Process Sheet

Customer : CU-DAR001 Dart Helicopters Services	Drawing Name : 350/355 AS X-TUBE FWD
Job Number : 27823	
Estimate Number : 12485	
P.O. Number : <i>N/A</i>	Part Number : D350748101
This Issue : 7/5/2006 S.O. No. : <i>N/A</i>	Drawing Number : IIN D350-748 P5 PREL <i>06.07.05</i>
Prsht Rev. : NC	Project Number : N/A
First Issue : <i>N/A</i>	Drawing Revision : PREL
Previous Run : <i>N/A</i>	Material : <i>N/A</i>
Written By : <i>[Signature]</i>	Due Date : 7/30/2006 Qty: 1 Um: Each
Checked & Approved By : <i>[Signature] 06.07.05</i>	
Comment : Est Rev A New Issue 06-07-05 JLM

Customer : CU-DAR001 Dart Helicopters Services Drawing Name : X-TUBE AS 350/355 HI FWD
 Job Number : 27823A
 Estimate Number : 12484
 P.O. Number : N/A Part Number : D350748141
 This Issue : 7/5/2006 S.O. No. : N/A Drawing Number : D350-748-141 PREL
 Prsht Rev. : NC Project Number : N/A
 First Issue : N/A Type : LANDING GEAR Drawing Revision : PREL
 Previous Run : N/A Material : N/A
 Written By : Due Date : 7/30/2006 Qty: 1 Um: Each
 Checked & Approved By : *06-07-05*
 Comment : Est Rev: A New Issue 06-07-05 JLM

DESIGN 90	DRAWN BY	DART AEROSPACE LTD HAWKESBURY, ONTARIO, CANADA	
CHECKED	APPROVED	DRAWI

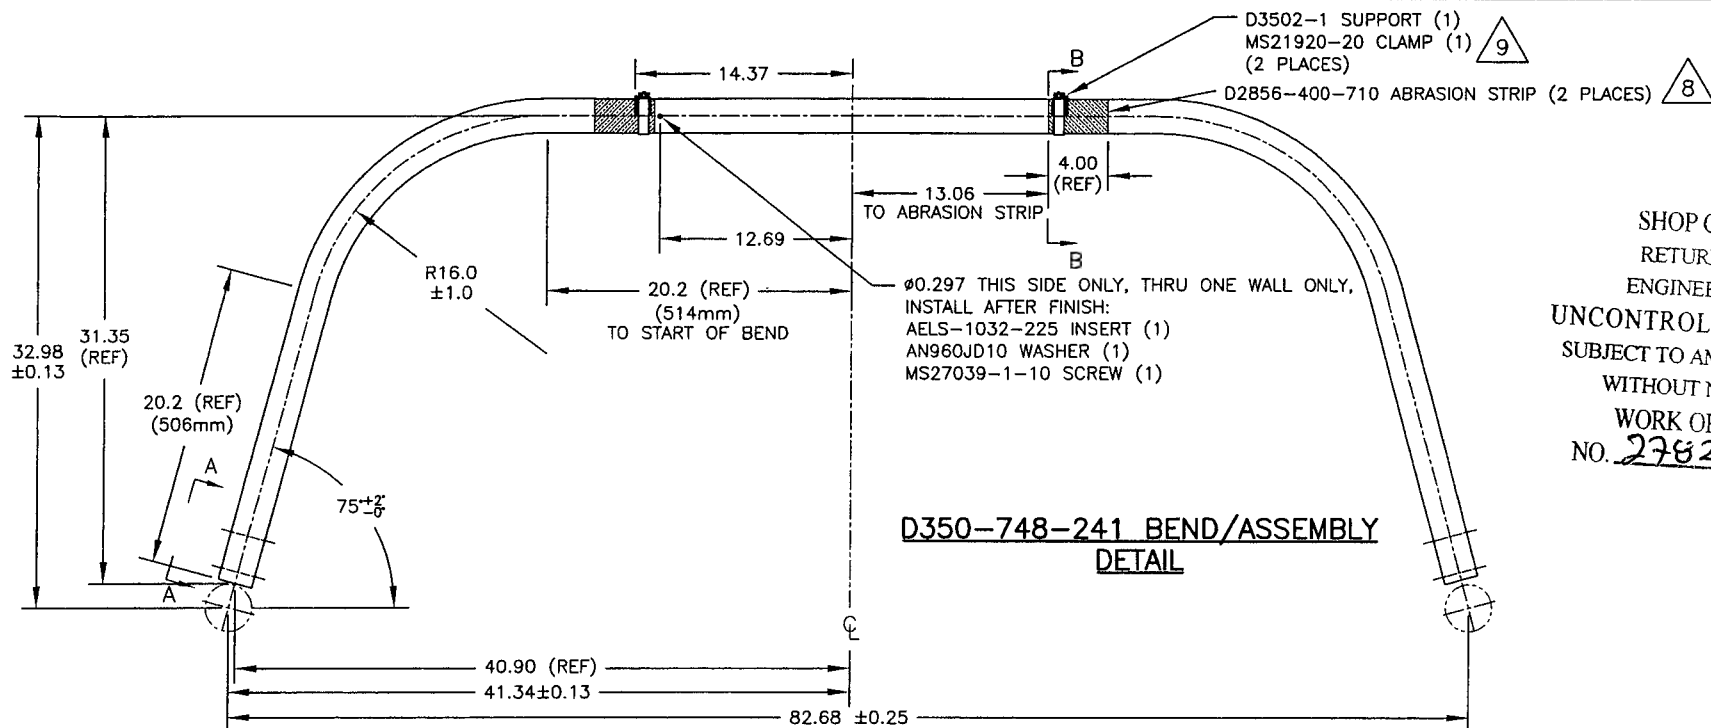
From: Chris Provencal [mailto:cprovencal@dartaero.com]
Sent: Monday, October 02, 2006 2:17 PM
To: David Shepherd (David Shepherd)
Cc: 'S Shahbazian'; 'Bill Beckett (Bill Beckett)'
Subject: 350 xtube cad plating

There is another set of 350 xtubes they want to send out tomorrow. I don't know if you've had a chance to review the cad plating issue. They're eager to get a response.

-I originally told you that the magnetic particle was done first. That was the plan, but they ended up following the drawing (cad->magnetic). The invoice I sent you gives the correct order the work was done.

-The cad plating was done to AMS-QQ-P-416B (issued 2004 by SAE) instead of the drawing's' QQ-P-416F (issued 1991 by military). I don't see a problem with this since it's a more current issue, and the only reason specified QQ-P-416F is because that's what the "old" never-used supplier suggested.

-The dims were re-checked after cad plating and the dimensions did not change.

-An NCR has been created to address the problem with the work orders. The bigger issue is that one was sent to a customer and we need to take action on that one asap.

From: David Shepherd [dshepherd@dartaero.com]
Sent: October 3, 2006 10:03 AM
To: 'Chris Provencal'
Cc: 'S Shahbazian'; 'Beckett, Bill'
Subject: RE: 350 xtube cad plating

I think the modified CAD plating procedure is acceptable.

As we discussed, I had some concern about the stress relieving comment on the packing slip because I didn't realize that by heating up the tubes, we would be stress relieving them. We didn't test our crosstubes in a stress relieved condition. The crosstubes we tested had compressive stresses in the tensile stress areas of the crosstube. However, because the highest stress areas are in the unbent portion of the crosstube and because I think we had so much margin in our drop test (no shock absorbers, damaged parts, overloaded, etc ...), my gut tells me that we are OK and I don't think we need to re-test.

I'm glad to hear that we are dimensionally checking the crosstubes after all the heating. I think this step should be added to the work order on receiving inspection for every crosstube.

As we discussed, I think a drawing revision is in order. I think reference to a QSI for the procedure outlined on the packing slip would be best.
